Re: Petition No. 1303 - 1069 East Main Street, Stamford, Connecticut

In preparation for the installation of the facility approved in Petition No. 1303, the Cellco Partnership d/b/a Verizon Wireless (Cellco) construction team determined that the location for the roof-top tower and equipment cabinets needed to be shifted slightly (approximately six (6) feet) to the west of the approved location. To accommodate this shift, the steel mounting platform has been reconfigured. These modifications are required so that Cellco can provide some additional clearance between its equipment and existing equipment on the roof and to accommodate the landlord's need to modify an existing roof hatch. Attached is a sketch from EBI Consulting depicting the shift in location and reconfiguration of Cellco's tower and equipment platform. The modified facility will be constructed in accordance with all applicable State and local codes.

SUPERIMPOSED PLATFORM FRAMING COMPARISON

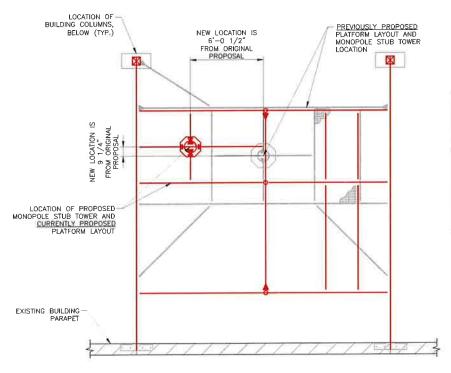
- PROPOSED EQUIPMENT, HANDRAILS, STAIRS/LADDERS, AND GRATING ARE NOT SHOWN FOR CLARITY
- THE LENGTH OF THE PREVIOUSLY PROPOSED PLATFORM HAS BEEN CORRECTED FROM 26' TO 23'-6" TO MATCH BUILDING COLUMN SPACING DIMENSIONS, ADJUSTMENT IS IN KEEPING WITH THE ORIGINAL DESIGN INTENT.
- FRAMING AND EQUIPMENT SHOWN ON THIS EXHIBIT IS INTENDED AS A SCHEMATIC REPRESENTATION ONLY. REFER TO CONSTRUCTION DRAWINGS BY EBI CONSULTING FOR MORE DETAILED INFORMATION.
